■ AIR CONDITIONER

General

► System Diagram **◄**

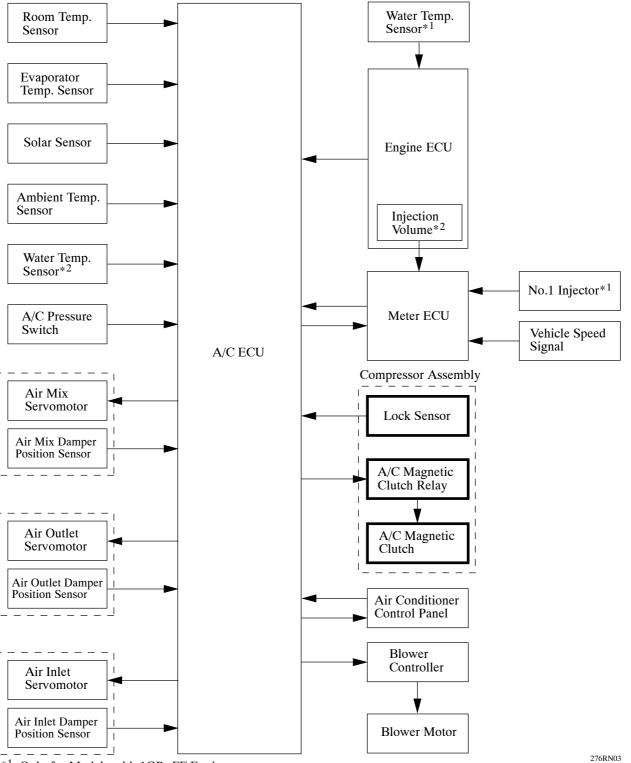
• On the models equipped with the 1GR-FE engine, the ECU to control the compressor has been changed from the Engine ECU to the A/C ECU.
